INDIANA DEPARTMENT OF TRANSPORTATION

AGENDA

February 17, 2011 Standards Committee Meeting

RE: Agenda for the February 17, 2011 Standards Committee Meeting

601-BAGR-01 ROADSIDE BRIDGE APPROACH GUARDRAIL

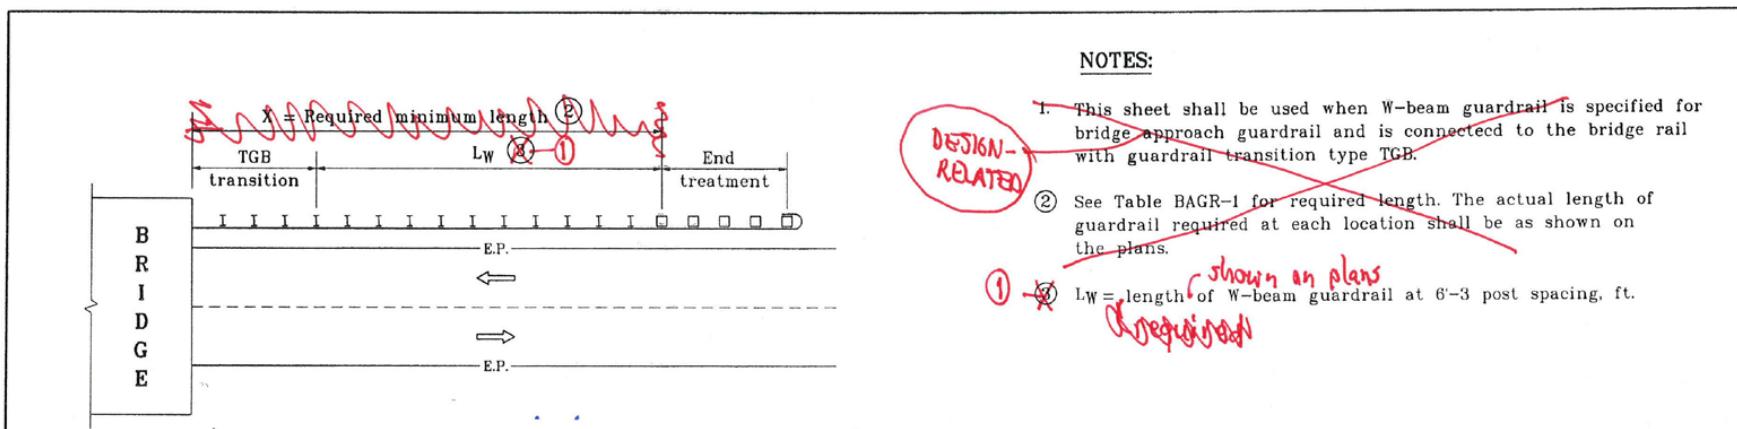
REVISION TO STANDARD DRAWINGS

601-BAGR-02 MEDIAN BRIDGE APPROACH GUARDRAIL

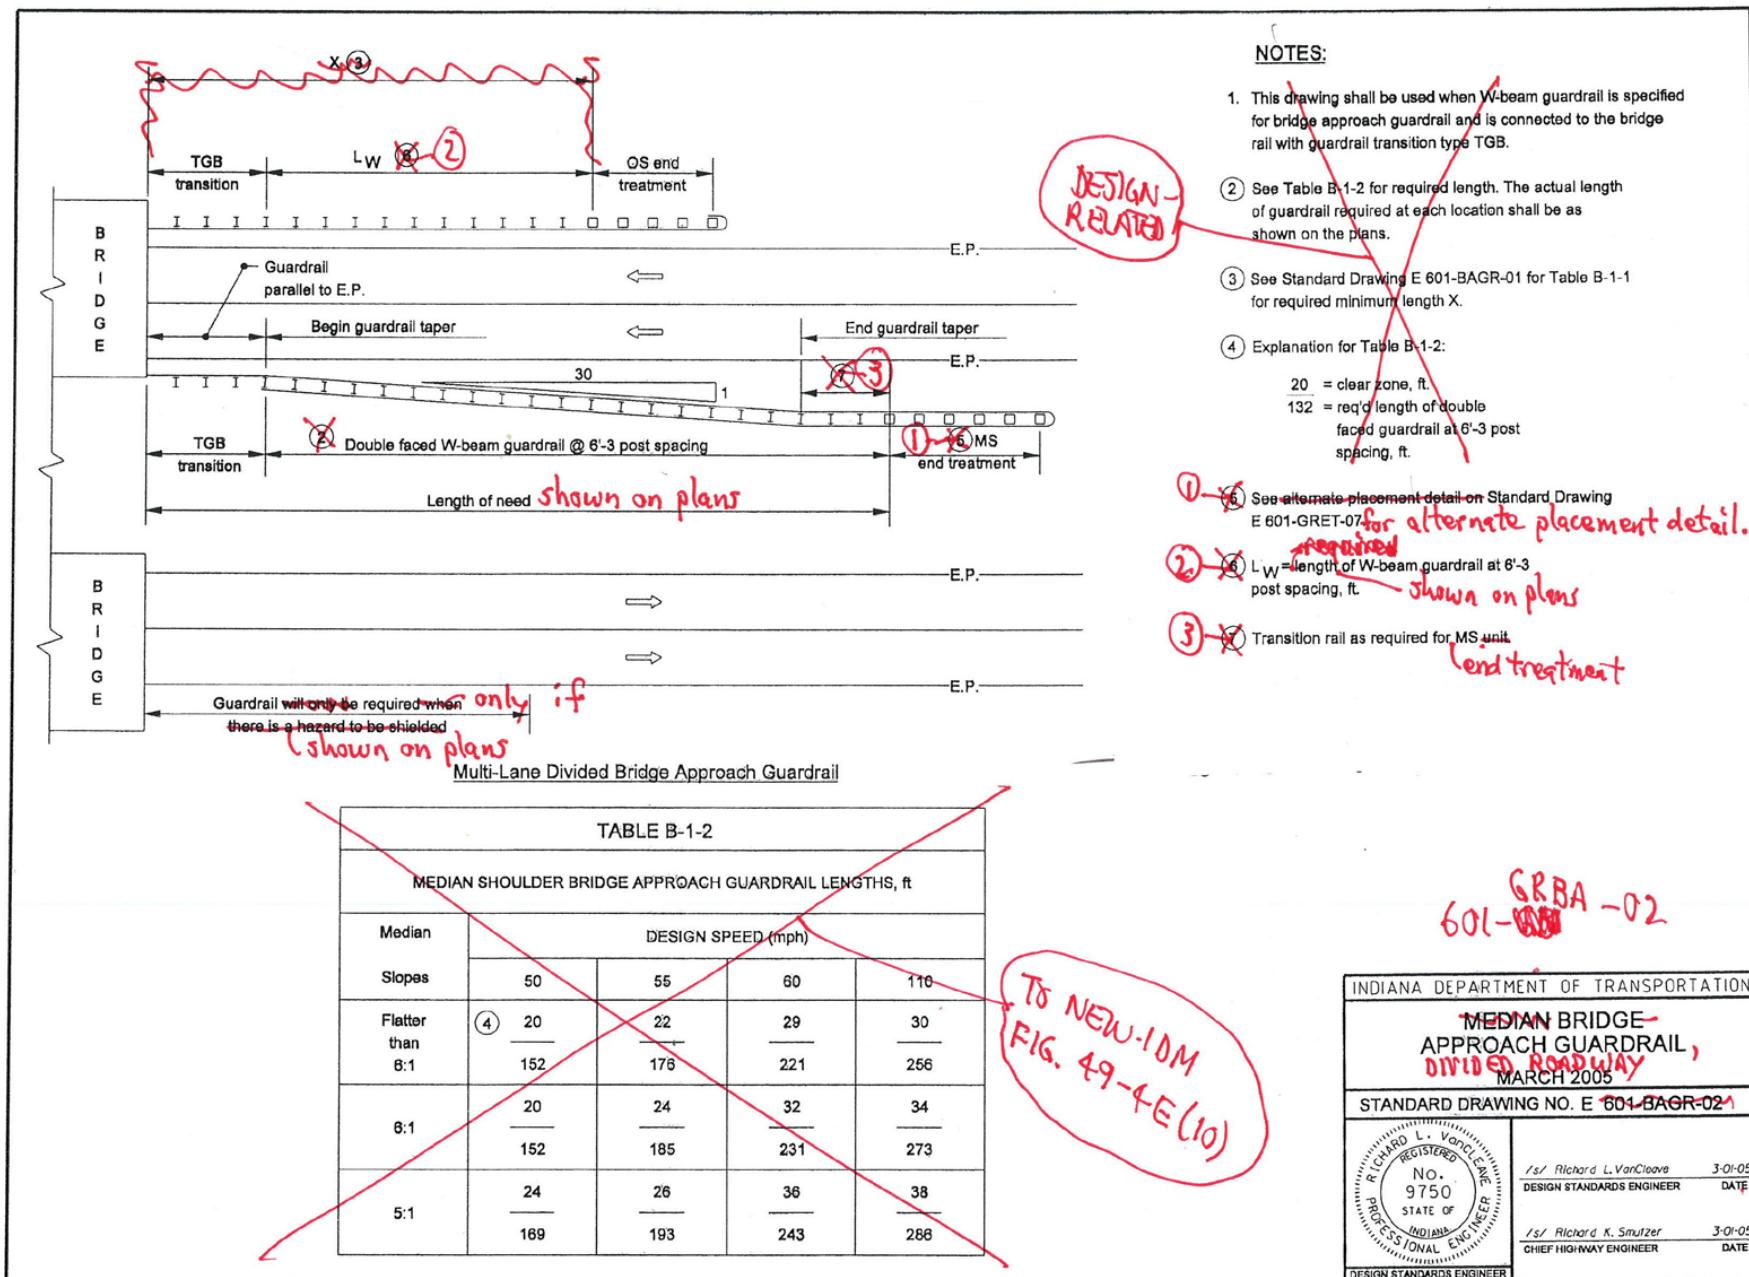
REVISION TO STANDARD DRAWINGS

601-MPPG-01 MEDIAN PIER PROTECTION GUARDRAIL

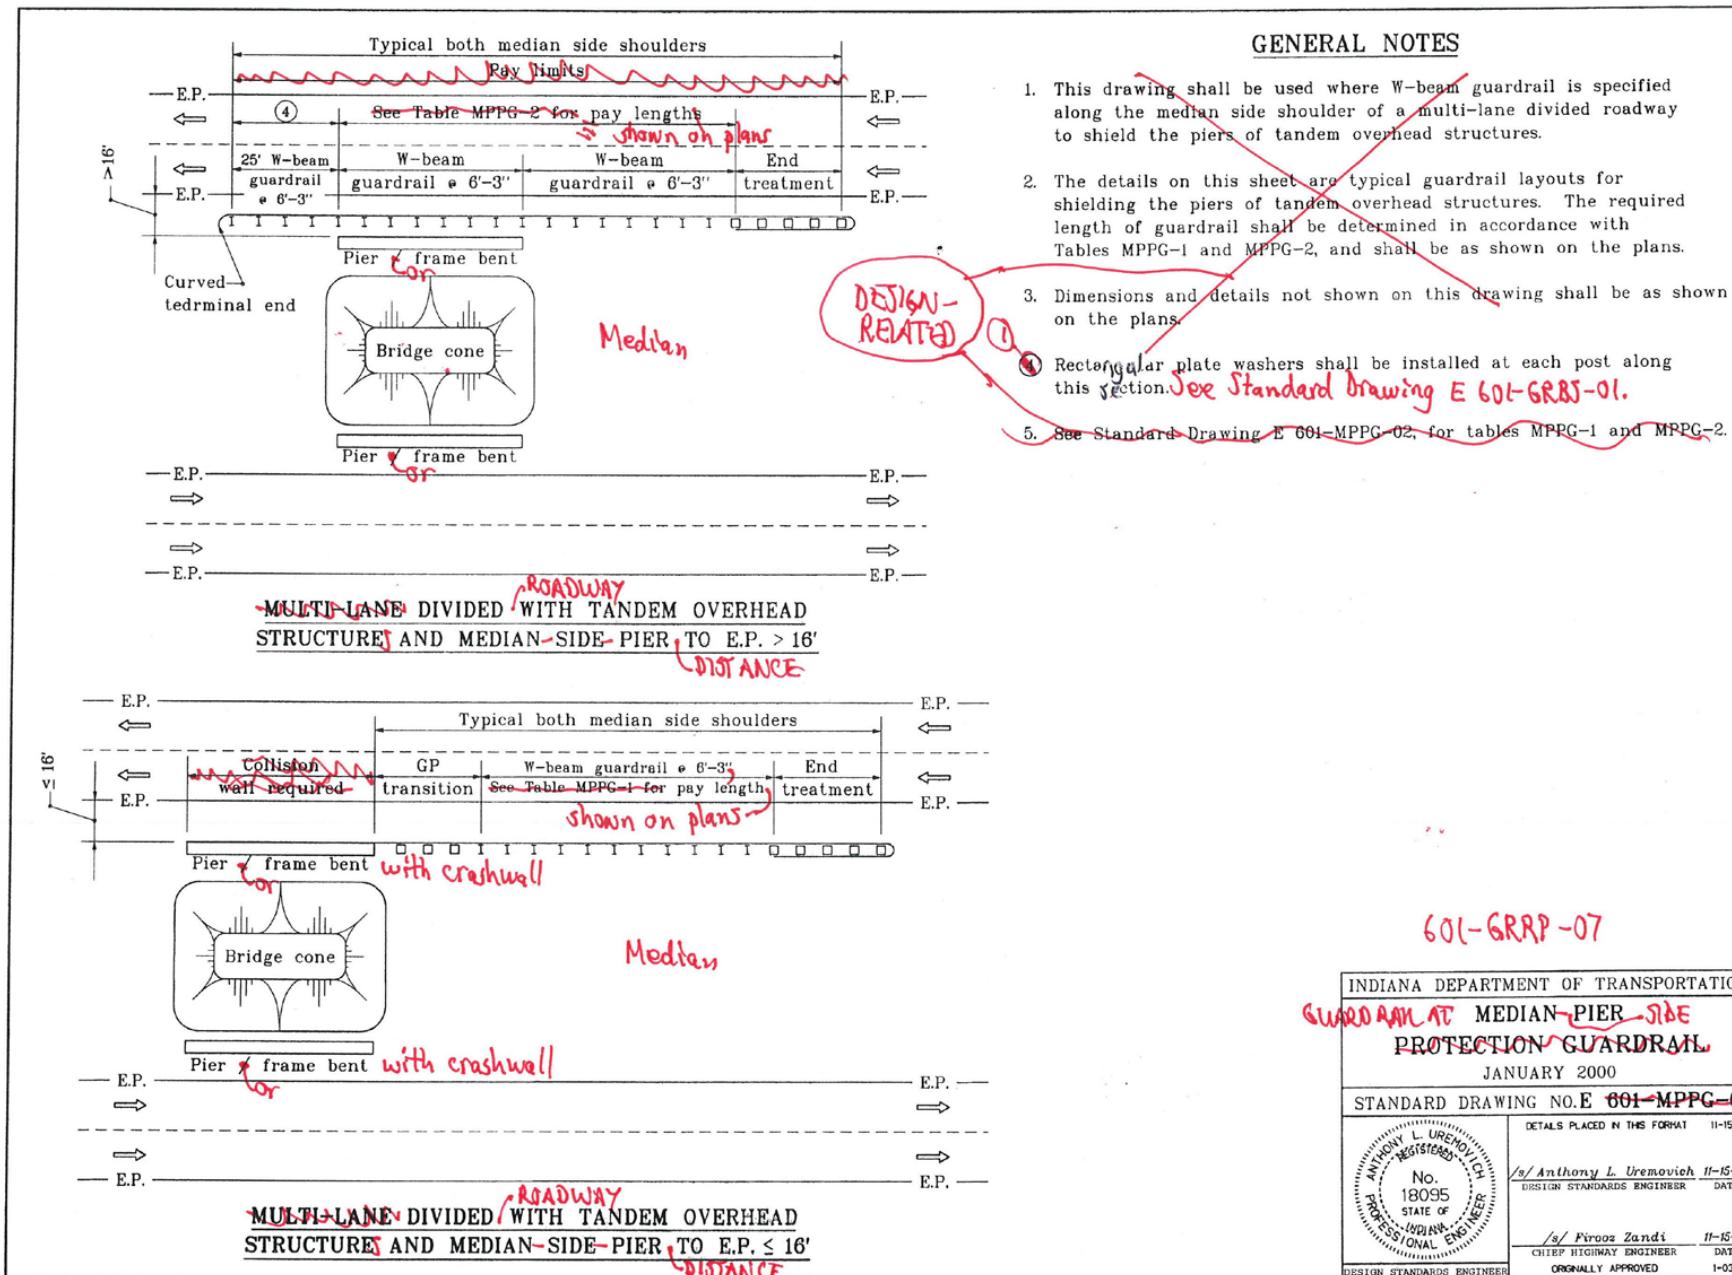
REVISION TO STANDARD DRAWINGS

601-RPPG-04 ROADSIDE PIER PROTECTION GUARDRAIL

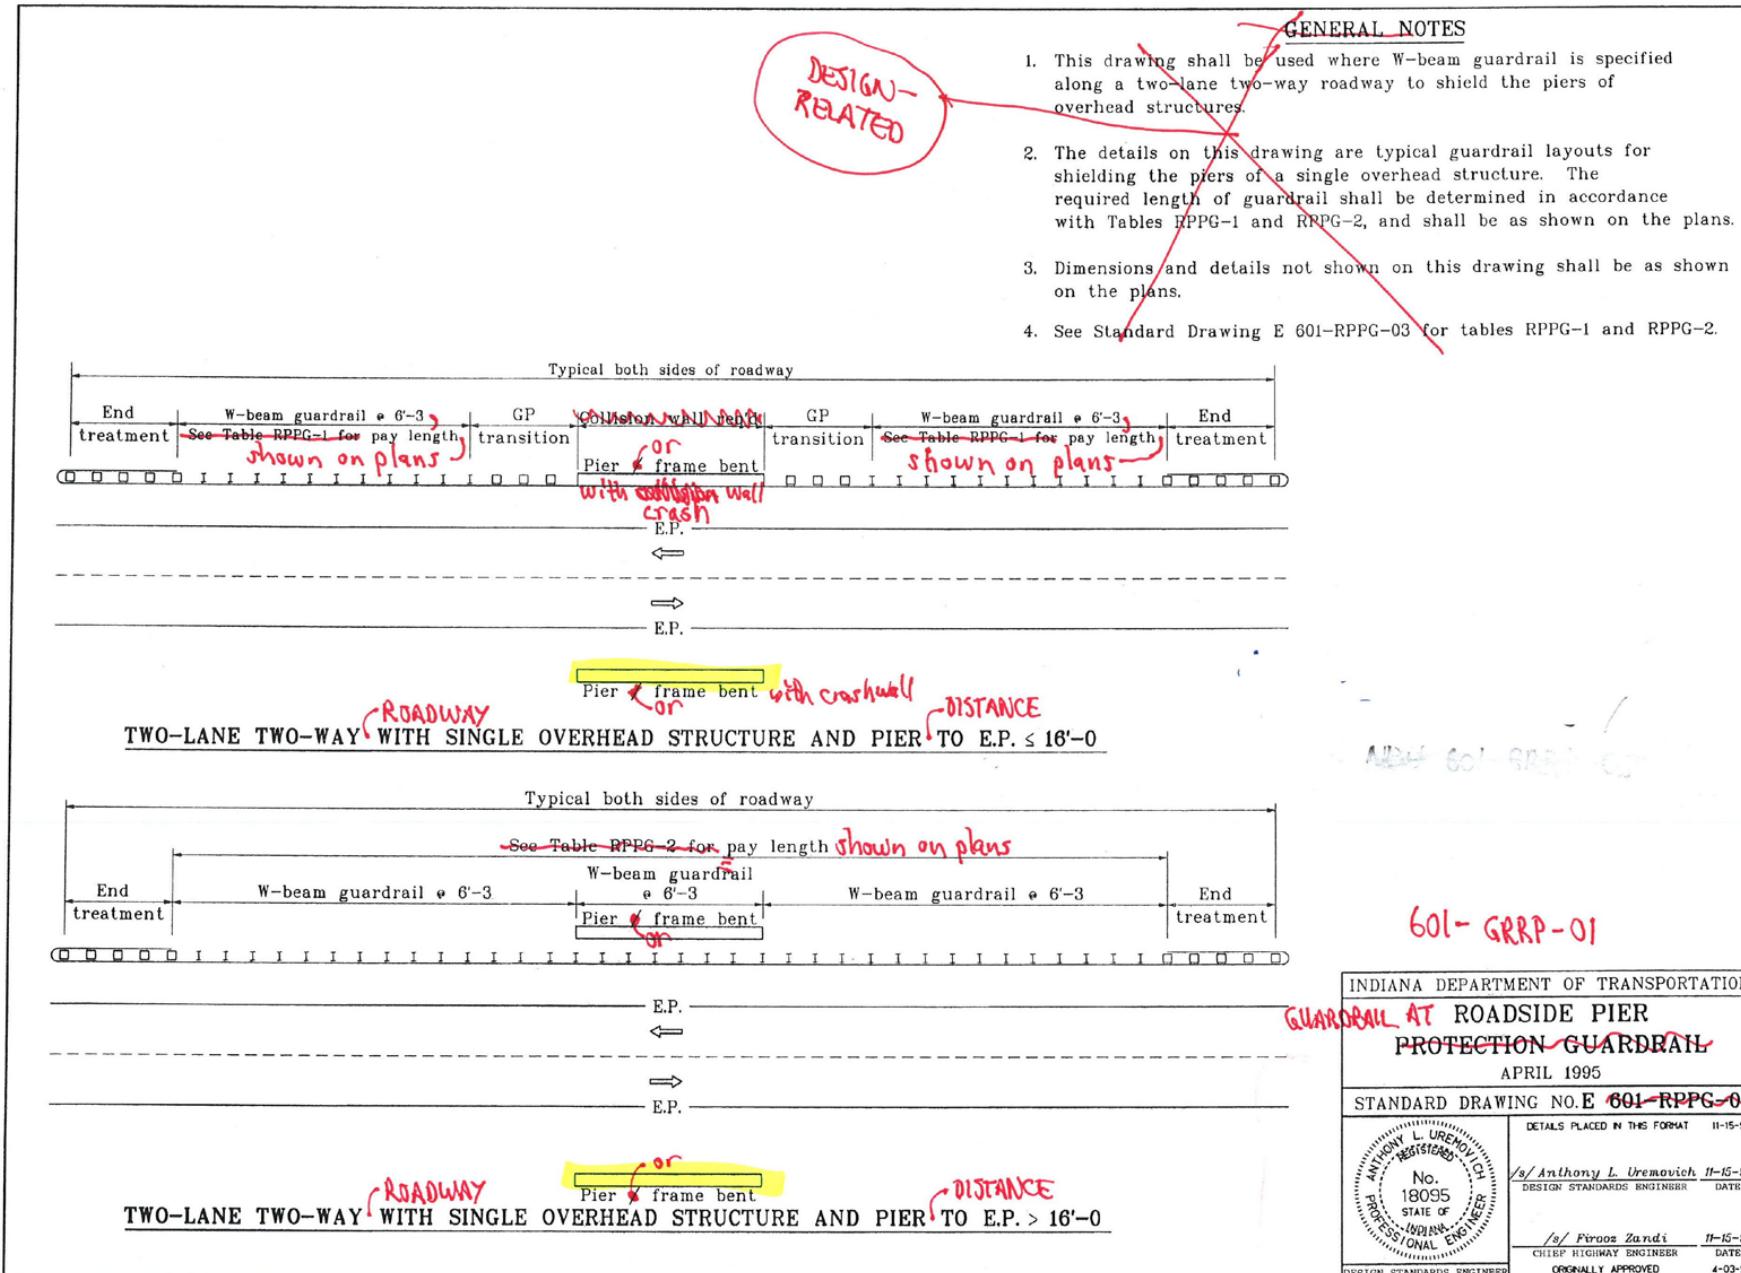
REVISION TO STANDARD DRAWINGS

601-RPPG-05 ROADSIDE PIER PROTECTION GUARDRAIL

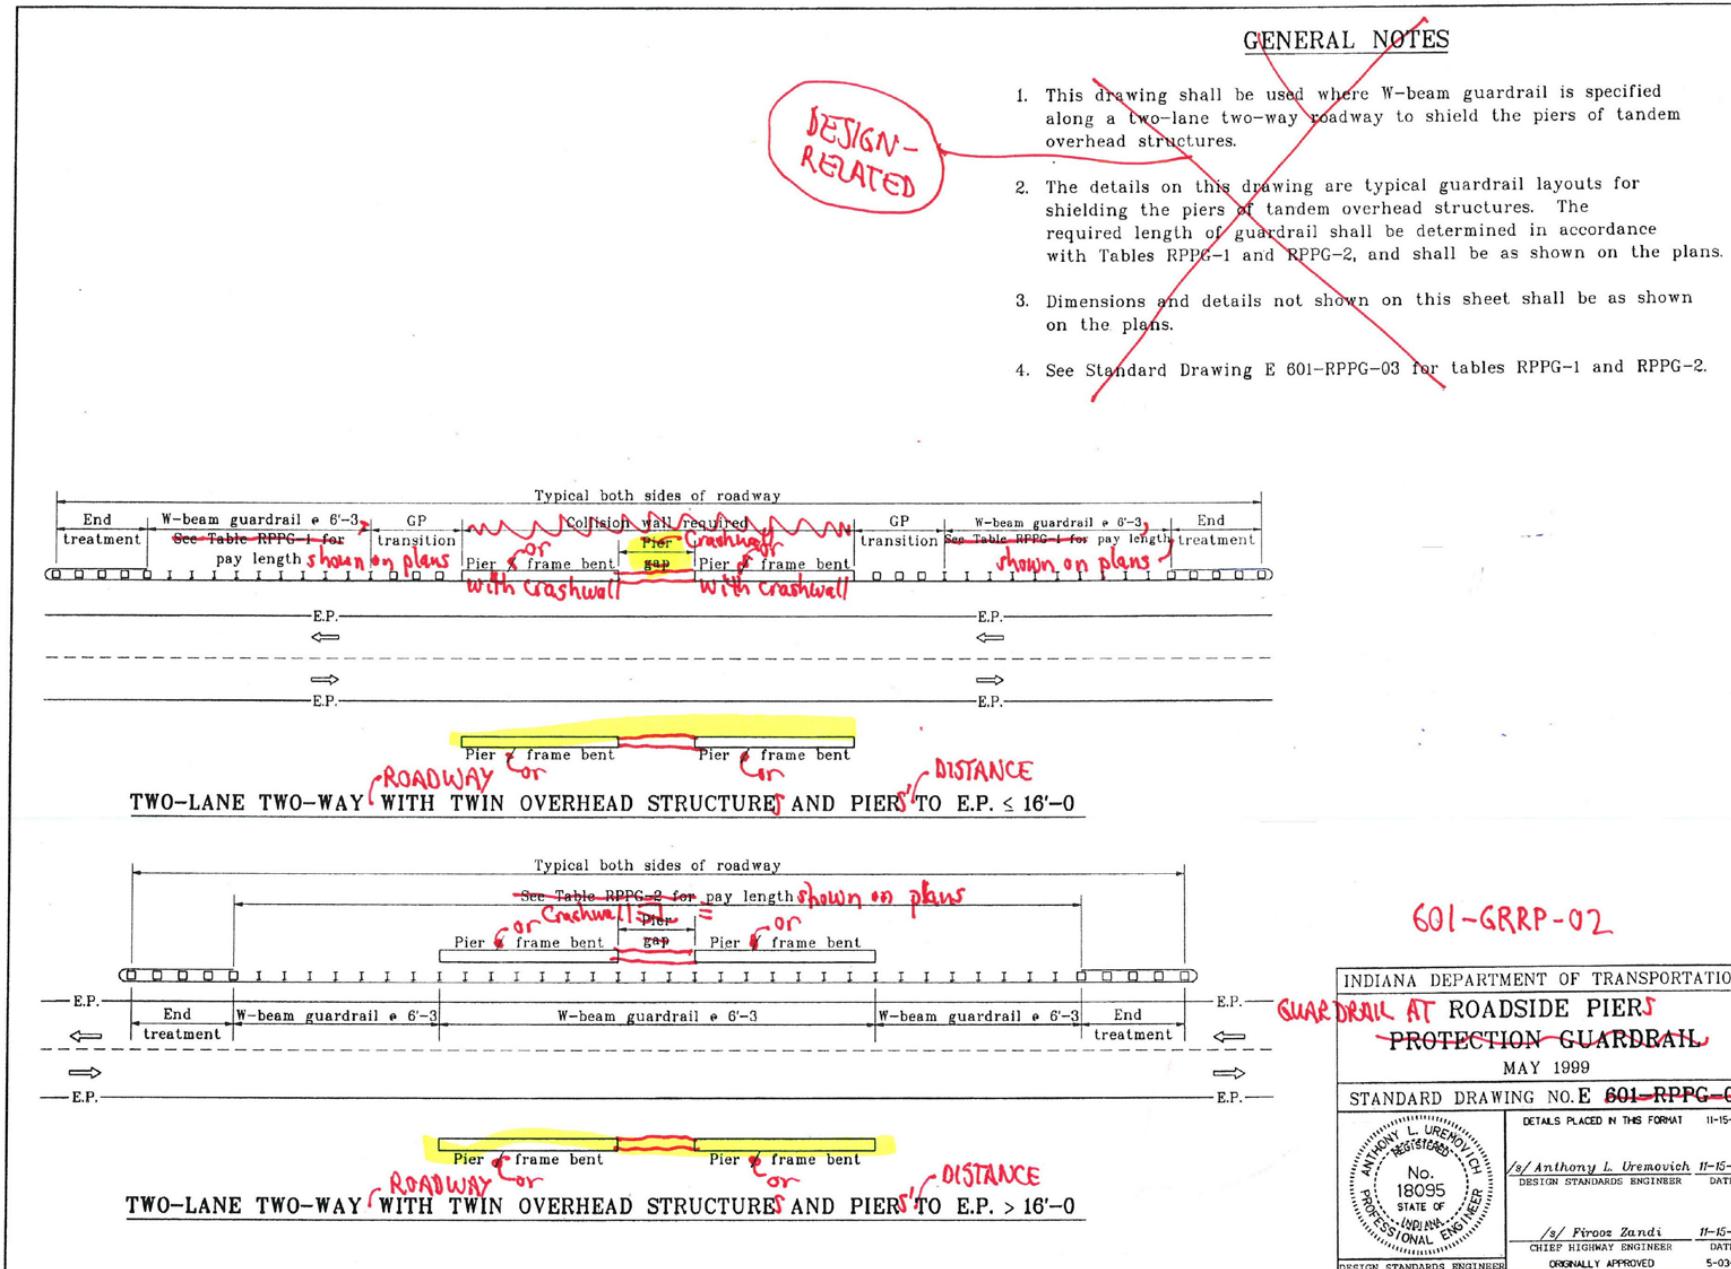
REVISION TO STANDARD DRAWINGS
